# Access Compliance Report

## Public Rights-of-Way

### (Curb Ramps)

Intersection ID: 24964	Main Street: HUGH_FOREST_RD	Cross Street: TUCKERBUNN_DR	Location: NW
ADA ID: 844DB5AA9754	Ramp Type: Perp	Initial Pass/Fail: Fail	Overall Compliance: No
		Severity Score: 25

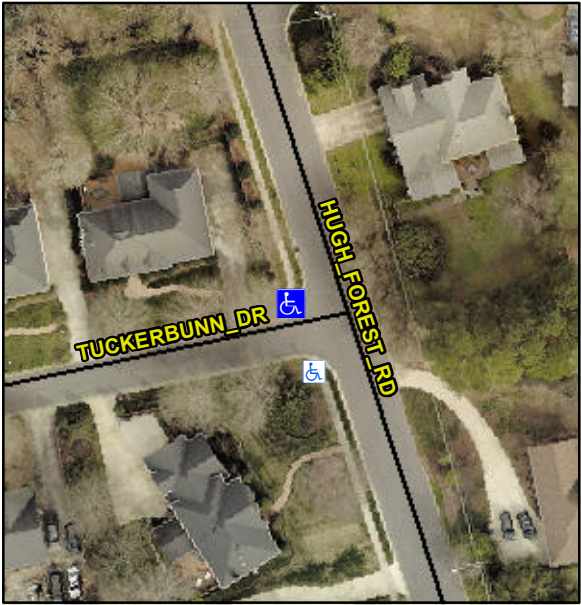
Codes/Mitigation Info/Possible Solution			Field Measurements/Component Compliance		
	Possible Solutions:		<b>Compliance</b>	<b>Description</b>	<b>Data</b>
	<b>Remove &amp; Replace Entire Ramp.</b>		<b>Yes</b>	Ramp Length (in)	48.0
			<b>N/A</b>	Ramp Width (in)	48.0
			<b>N/A</b>	Flare Type LT	N/A
			<b>N/A</b>	Flare Slope LT (%)	N/A
			<b>N/A</b>	Flare Traversable LT?	N/A
			<b>N/A</b>	Flare Traversable RT?	N/A
			<b>N/A</b>	DWS Provided?	N/A
			<b>N/A</b>	DWS Contrast?	N/A
			<b>N/A</b>	DWS Length (in)	N/A
<p>Surveyor Notes:</p> <p><b>N/A</b></p>			<b>N/A</b>	DWS Full Width?	N/A
			<b>N/A</b>	DWS Offset (in)	N/A
			<b>N/A</b>	Shared Landing?	N/A
			<b>N/A</b>	Gutter Ponding?	N/A
			<b>N/A</b>	Gutter Lip Ht (in)	N/A
			<b>N/A</b>	Painted X Walk1?	No
			<b>N/A</b>	X Walk 1 Direction	To S
			<b>N/A</b>	X Walk 1 Width (in)	N/A
			<b>N/A</b>	X Walk 1 Slope (%)	5.6
			<b>N/A</b>	X Walk 1 X Slope (%)	8.4
<p>PROW/ADA:</p> <p><b>Not Found, R304.5.3</b></p>			<b>N/A</b>	X Walk 2 Direction	N/A

<b>N/A</b>	X Walk 2 Width (in)	N/A
			<b>N/A</b>	X Walk 2 Slope (%)	N/A
			<b>N/A</b>	X Walk 2 X Slope (%)	N/A
			<b>N/A</b>	Ramp inside XWalk1?	N/A
			<b>N/A</b>	Ramp inside XWalk2?	N/A
			<b>N/A</b>	Clear Space?	N/A
			<b>N/A</b>	Clear Space to XWalk (in)	N/A
			<b>N/A</b>	Storm Grate/Utility Hazard?	N/A
			<b>N/A</b>	Storm Grate/Utility Type	N/A
<p>Total Cost:</p> <p><b>\$ 1850.00</b></p>			<b>N/A</b>	Surface Condition? (G/P)	<b>Good</b>
			<b>N/A</b>
